LANDSCAPE DESIGN AND ACCESS STATEMENT

DEVELOPMENT AT BROOMHILL, TALLAGHT, DUBLIN

MAY 2022 / PROJECT NO. 7116

15.0 Response to An Bord Pleanála Opinion

- Legend:
- Permeable Surface/Paving areas
 - Bio-Retention Areas
 - Tree Pits

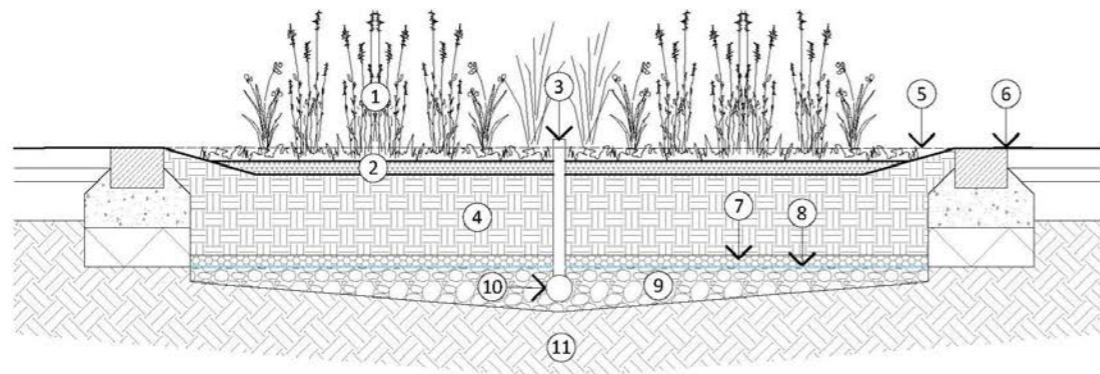
The applicant is required to include further Sustainable Drainage Systems (SuDS) in the proposed development such as but not limited to the following:

- Tree pits included in parking areas
- Rainwater harvesting systems
- Swales, Rain Gardens and Detention basins etc in central public plaza areas

The applicant shall submit a revised Surface Water Drainage layout drawing showing the further inclusion of SuDS and how these are integrated into the surface water drainage network on site.

The applicant is requested to submit cross section details of all proposed SuDS features for the proposed development such as Porous surfaces, Tree pits, Swales, Rain Gardens, Green roofs, Detention basins and Rainwater harvesting systems.

Bioretention areas have been added to the central area of the site. Tree pits have been proposed for the car parking area.

Further information, details and cross sections regarding the sites SuDS strategy have been provided in Section 14.0 of the report.
